BOARD MEETING DATE: January 10, 2014

AGENDA NO. 19B

PROPOSAL: Proposed Amended Rule 1420.1 – Emission Standards for Lead and Other Toxic Air Contaminants from Large Lead-acid Battery Recycling Facilities

Figure 2-1
Arsenic Emissions at Quemetco

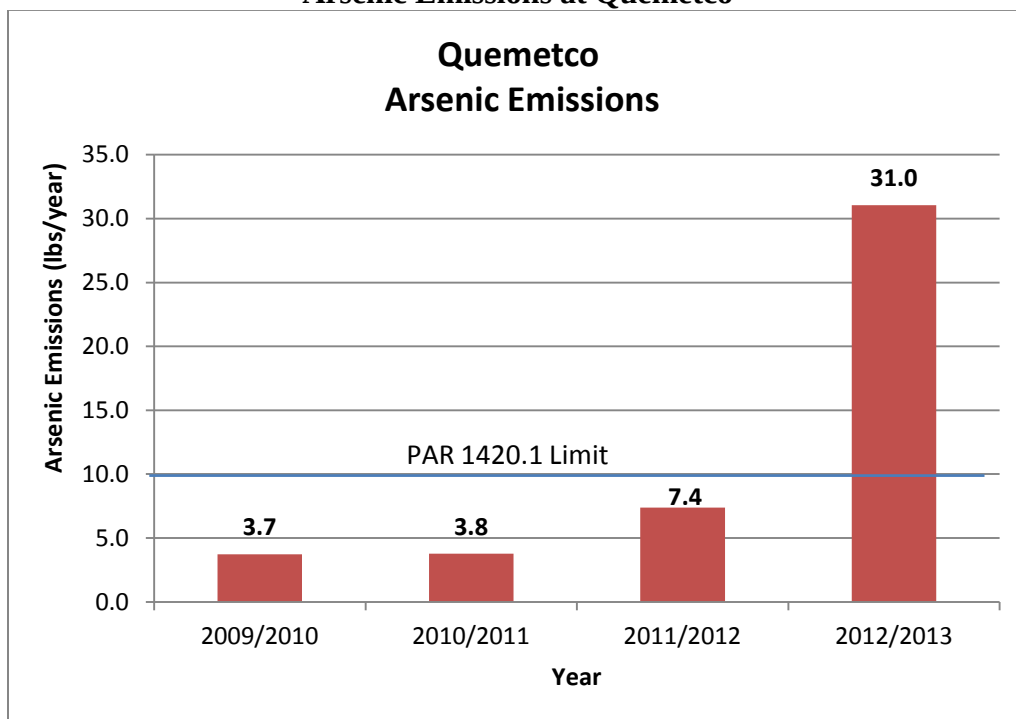
In October/November 2013, the SCAQMD staff also source tested arsenic, benzene, and 1,3-butadiene emissions from Quemetco’s WESP, RTO, and baghouses. Results from these 2013 source tests showed elevated arsenic, benzene, and 1,3-butadiene emissions. As shown in Figures 2-1, 2-2, and 2-3 below, arsenic emissions from the WESP and RTO were nearly 3.5 times higher than their 2012 source test which represented the highest emissions over the past three source tests conducted in 2009, 2010, and 2012. This 2013 source test also showed that arsenic, benzene, and 1,3-butadiene emissions exceed the PAR 1420.1 emission limits by a substantial margin.

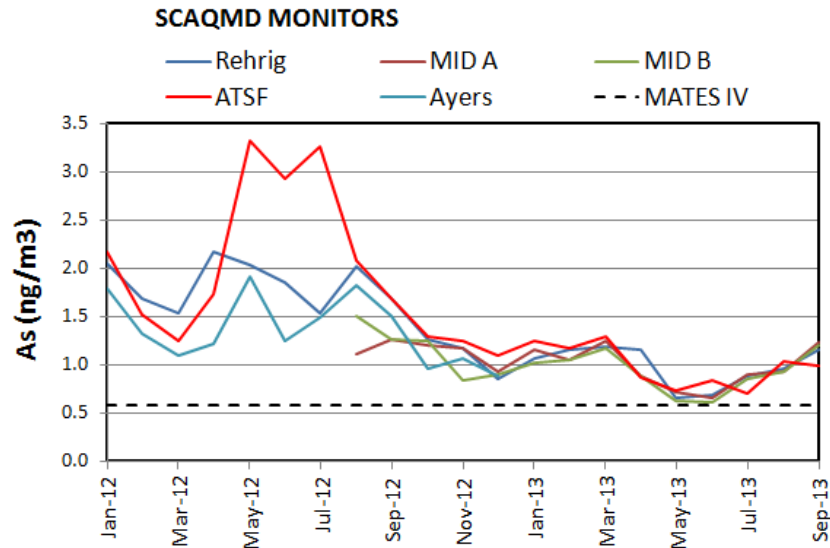
- 35. Comment:** PAR 1420.1 subparagraph (d)(5)(A) would require regulated facilities to submit a Compliance Schedule within 30 days of the rule adoption date describing how the final performance standards for arsenic, benzene, and 1,3-butadiene will be achieved by January 1, 2015. Subdivision (d) sets forth specific information that must be provided in the Compliance Schedule. Given the amount of information that must be included, 30 days is too short. The District should allow regulated facilities 90 days to prepare and submit the Compliance Schedule. Likewise, the permit application timing in subparagraph (d)(5)(B) should be extended to 120 days after adoption.

Response: The dates for the Compliance Schedule and permits are included to ensure increments of progress are achieved so that the affected facilities can meet the January 1, 2015 deadline. In developing the Compliance Schedule ~~final compliance date~~ for PAR 1420.1 the SCAQMD staff took into consideration the severity, breadth, and magnitude of the health risk and

the public health impact to many communities in the Basin. The schedule also took into consideration engineering and design, procurement, and construction as well as implementation of Rule 1402. The Rule 1402 process complements PAR 1420.1, allowing for earlier implementation of measures. Under Rule 1402, the Exide will be making a number of modifications that are consistent with modifications that are needed to meet the emission limits under PAR 1420.1 such as installation of a Neptune scrubber and a RTO. —The SCAQMD staff understands that the schedule is aggressive, but believes that it can be achieved by January 1, 2015. The SCAQMD’s Governing Board will receive this staff report with the responses to comments and can decide with all of the information presented if additional time is needed.

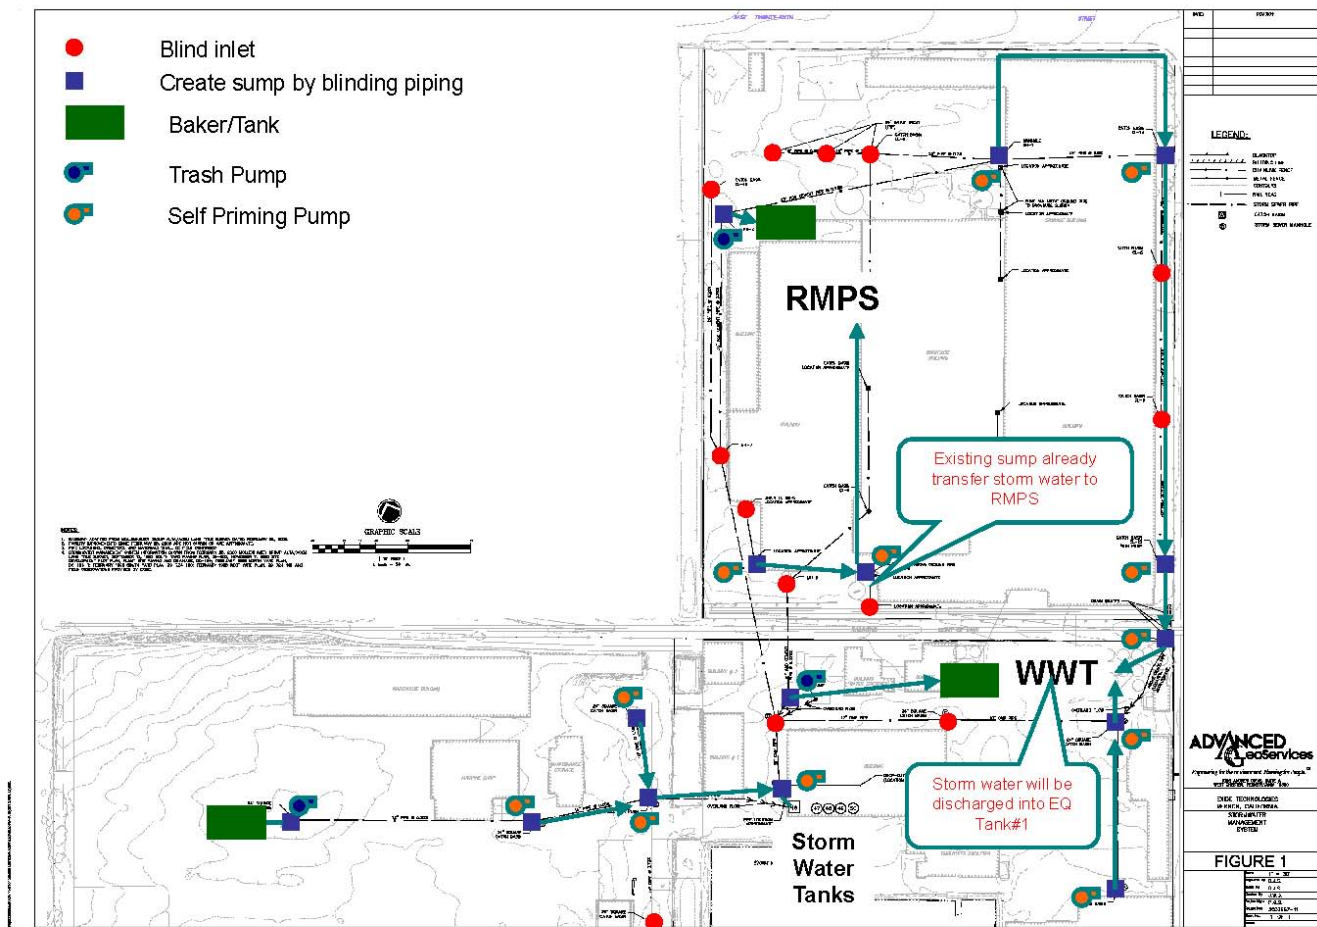
The commenter states that the energy impact analysis is unsupported by substantial evidence. Contrary to the commenter's opinion, the Draft EA accurately explains that the size of the pumps necessary to move the storm water collection to the wastewater treatment facility is not known at time. The increased energy demand noted by the commenter is based on the need to pump stormwater from a large storage capacity but this capacity is based on the size of the storm water retention pond. "Surface water runoff at Exide is controlled within the facility by a 2.8 million gallon storm (rain) water retention pond located on the southeast portion of the site." (The Exide Corporation Hazardous Waste Facility Permit Draft Environmental Impact Report (page 3-85)). The storm water is gravity fed to the storm water retention pond so there is a need for a larger capacity to allow for collection while sent to the wastewater treatment facility.

DTSC issued the Enforcement Order on August 12, 2010, which ordered Exide to immediately cease operation of the surface impoundment. (see Figure 3-1) DTSC staff said that the storm water containment pond cannot be permitted without an updated health risk assessment that is scheduled for submittal in 2015. Therefore, a temporary storm water treatment system large enough to safely treat storm water at the facility has been installed and operating. The existing temporary storm water system (see Figures 3-3, 3-5 and 3-6) includes above ground storage tanks and a pump system designed and installed to transfer storm water from the drop out system to the storm water tanks. Please see Response to Comment 3-33 for details on storm water containment pond and the existing storm water system in operation at Exide.

According to our records, there are at least nine pumps actively permitted through CARB's statewide equipment registration program (Unit numbers: PU04186, PU04224, PU04226, PU04227, PU04265, PU04266, PU04268, PU04341, PU04433) to power the existing storm water system. These existing pumps (see Figure 3-5) can be seen in Exide's Work Plan (see Figure 3-6) as part of the storm water collection and interaction with Raw Materials Processing System (RMPS) and the Waste Water Treatment (WWT).
